Memo

Subject: The Village Precinct, Alphington

As requested, please find below comment on the concept plans submitted for the Village Precinct.

GRADING 02
EDGE SECTIONS

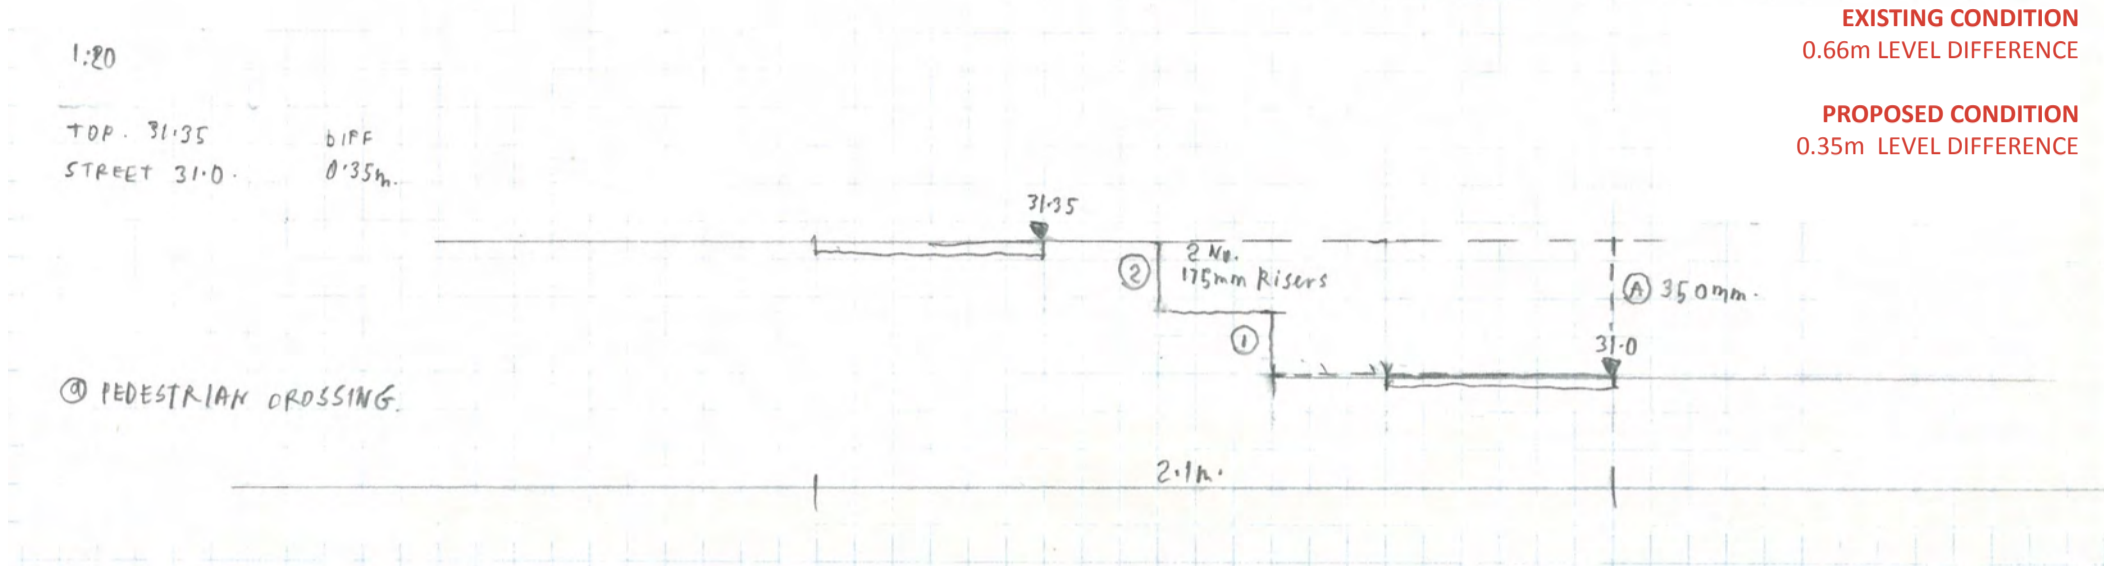
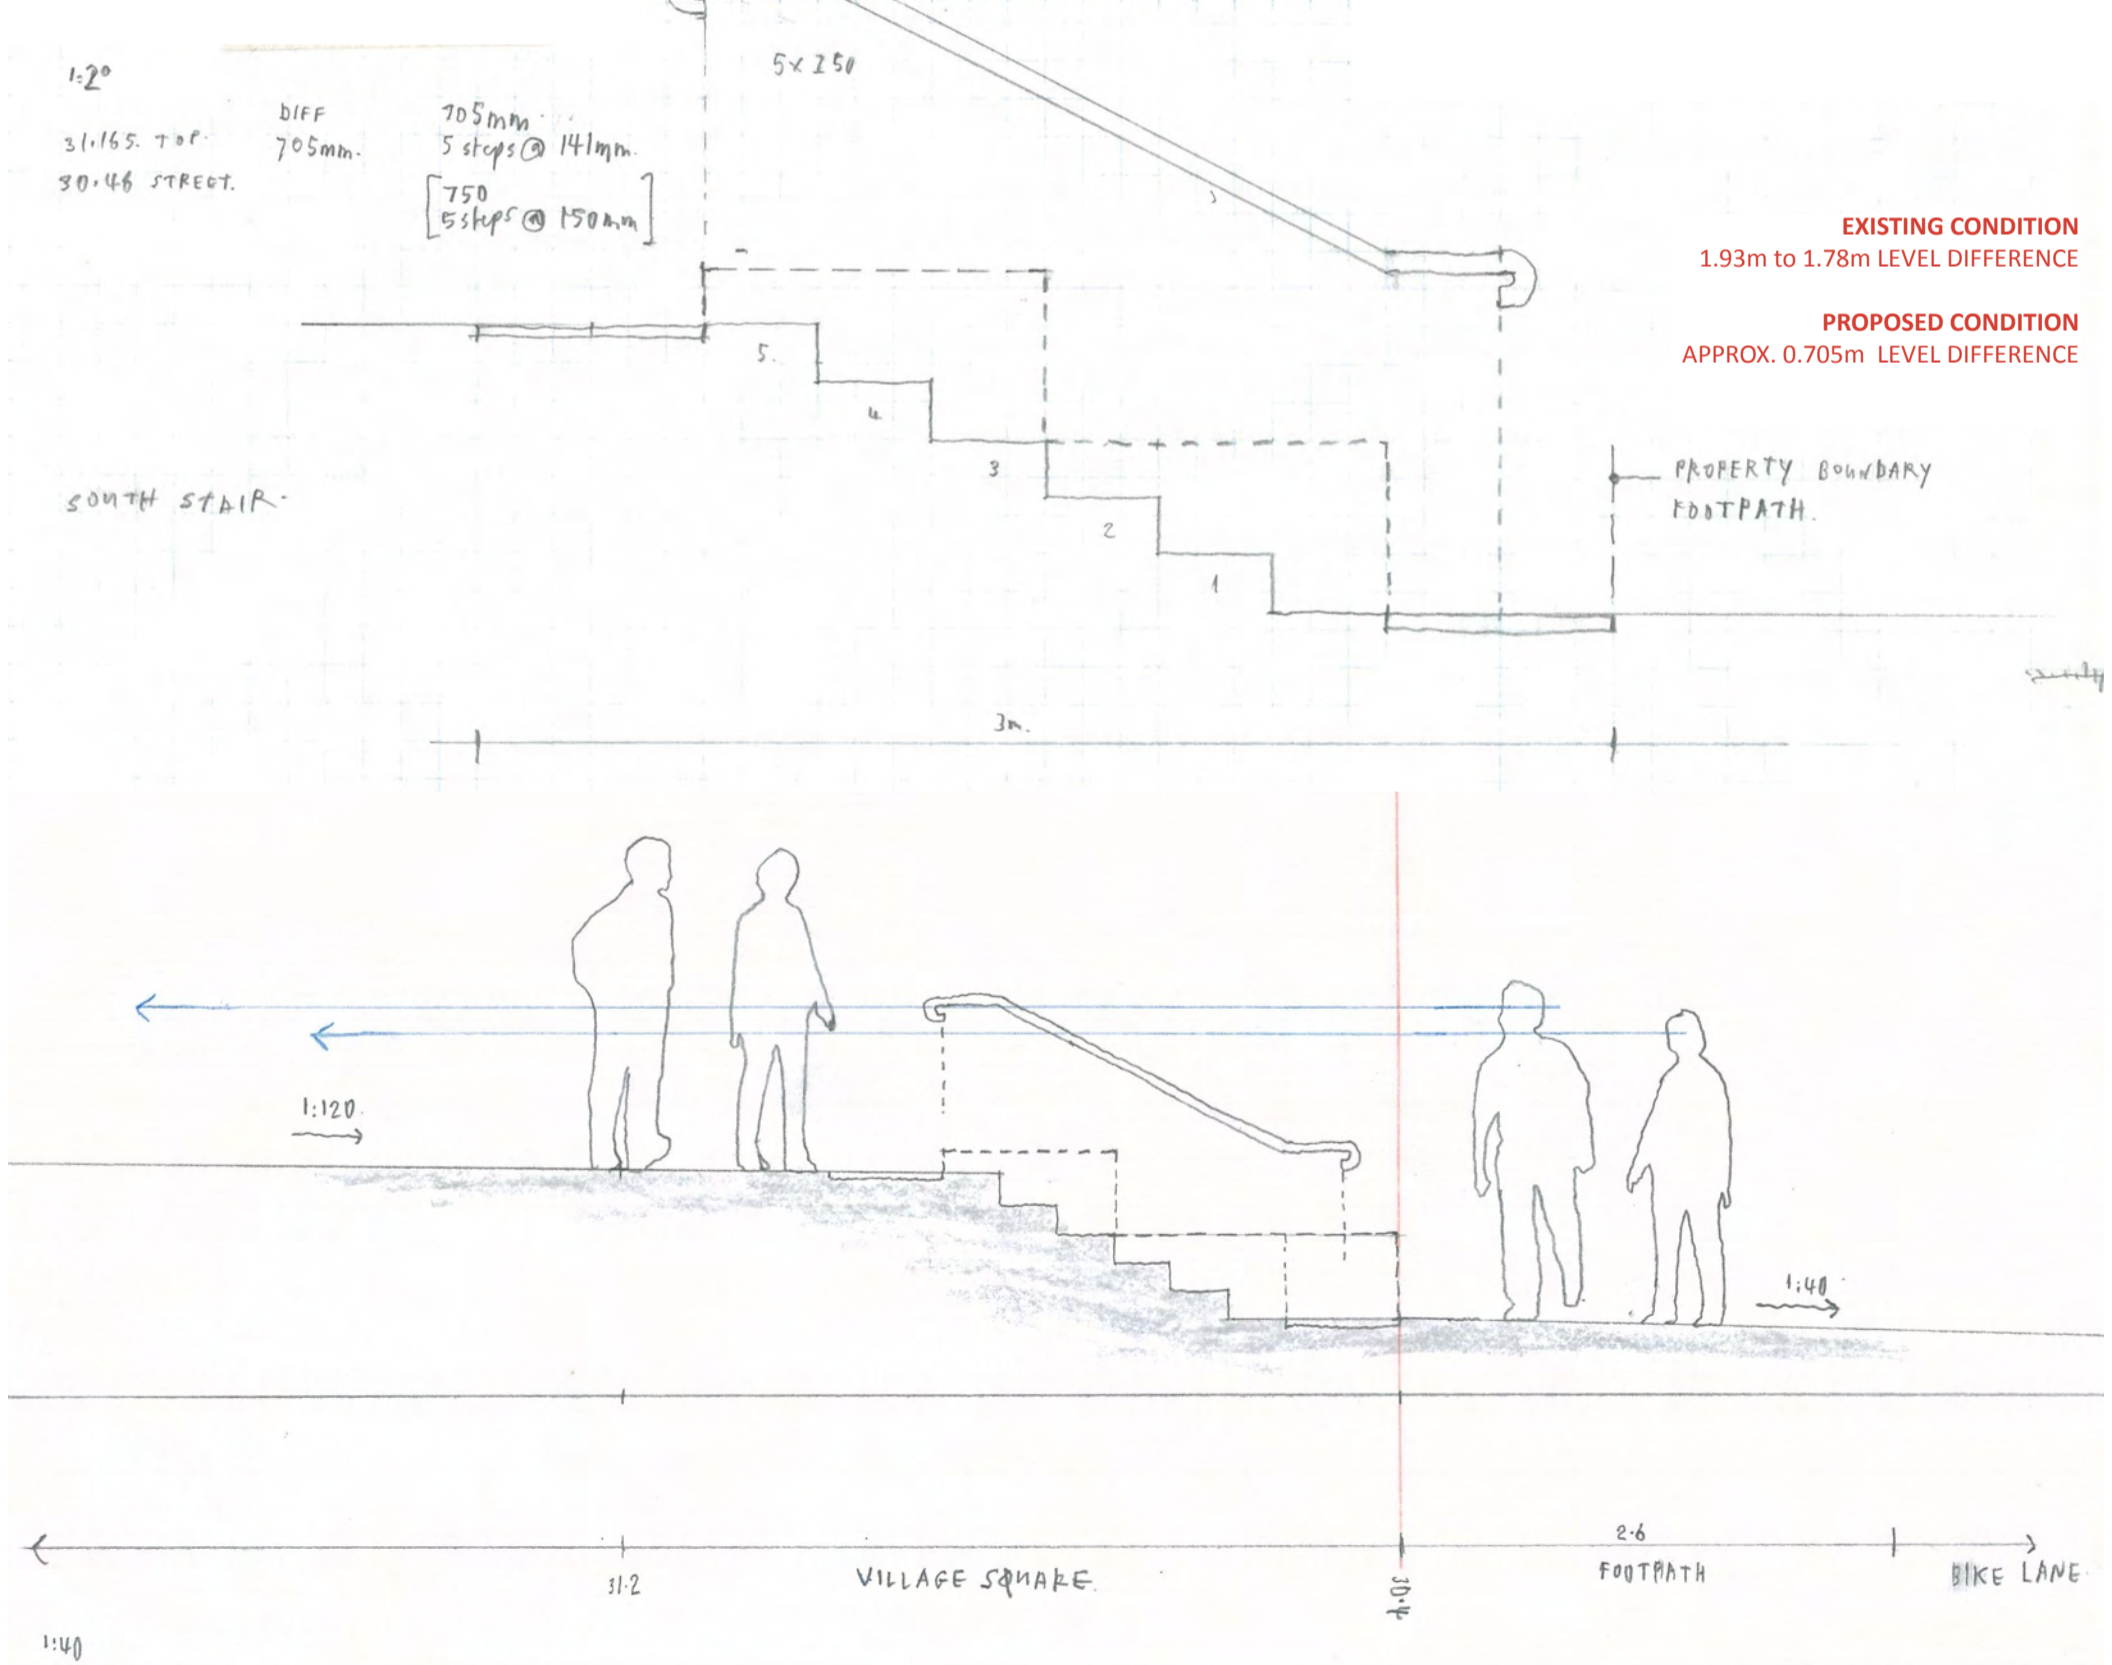
Grading Approach (Refer to attached Grading sketches 01 & 02)

- Create a positive interface between the Town Square and La Trobe Avenue to improve connectivity, access and visibility. The proposed plaza grades and edge treatment obscure views into the square from southern approach and a significant length of La Trobe Avenue footpath - Grade Town Square with overall precinct topography to reduce difference in levels between footpath and square.

SECTION A
PEDESTRIAN CROSSING EDGE 1:20

SECTION B
SOUTHERN STAIR 1:20 & 1:40
